## Change in Transmission Front Suspension

The change effects all vehicles after identification No. (chassis No.):

Coupe	110 407
Cabriolet/Hardtop	153 023
Roadster	87 492

Fig. 1

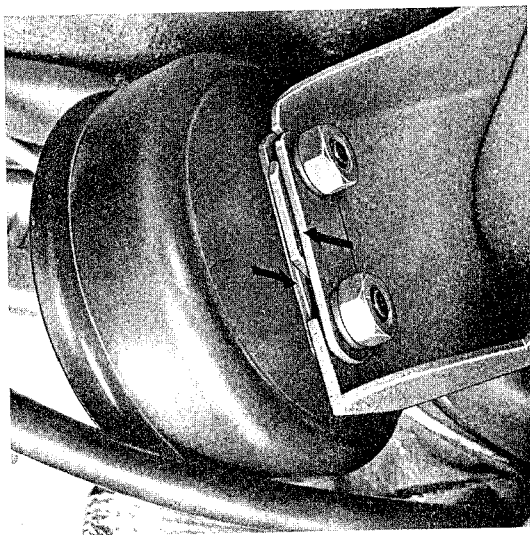
Beginning with transmission No. 35 001 a gear box cover with two support brackets is used, which connects the transmission by way of two rubber cushions to the rear suspension tube. The torque rod of the centrally supported transmission is no longer required and is omitted.

1. Before installation the two rubber mounts with sockets must be installed on the brackets of the gear box cover.
2. When engaging the transmission supports into the mounts on the body, note that the body section lies between the two clamping plates.

Fig. 2

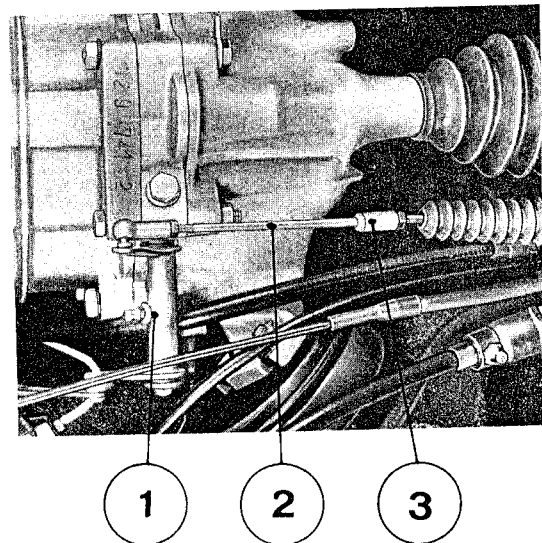
The throttle cable bell crank has been mounted on the bearing plate (intermediate plate) instead of the cover. For this reason an extension is required between the cable and bell crank.
